**Project: IEEE P802.15 Working Group for Wireless Personal Area Networks
(WPANs)**

Submission Title: assigned comments for draft D2

Abstract: proposes comment resolutions for a set of CIDs

(a) Output from PHY SAP

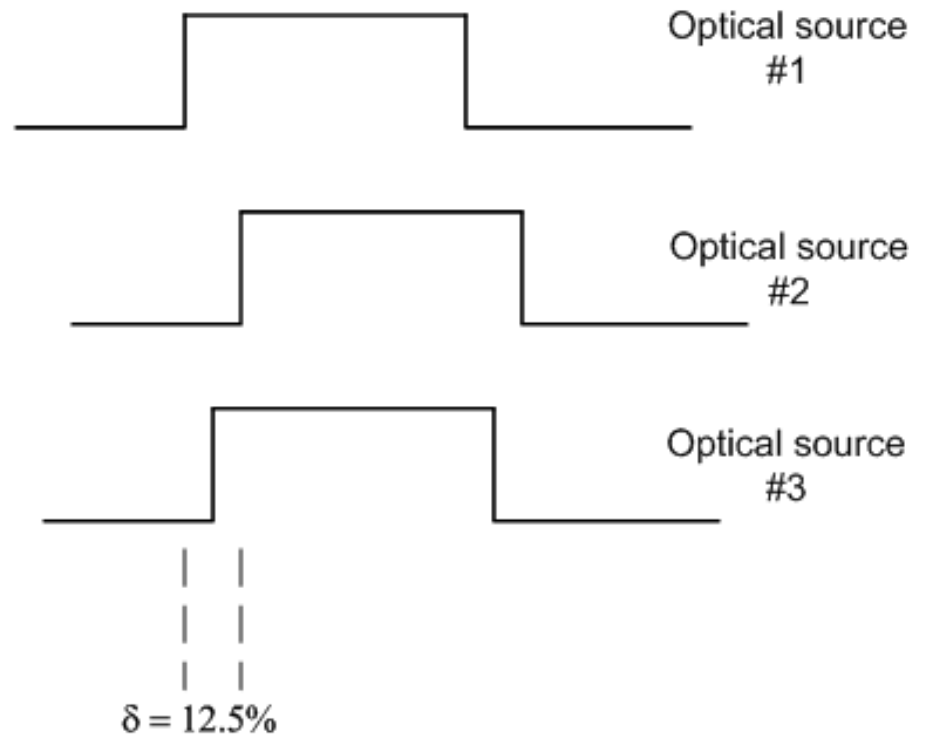
In the receiver side, ADC for PHY III should have at least 4 over times sampling rate to symbol rate.

For avoiding the degradation, the delay difference should be smaller than a half of the sampling period.

As a result, the allowable delay difference is $1/8$ of the symbol duration. So, Δ should be less than 12.5% of symbol clock.

Add subclause 5.1.x for “Maximum error tolerance for multiple optical sources”

Suggested text:

- If multiple optical sources are used, it is recommended the optical sources have similar frequency responses in order to assist communication. The digital input to all the optical sources from the PHY shall be synchronized. The maximum spread between the clock edges at the output of the optical sources shall not vary by more than 12.5%.
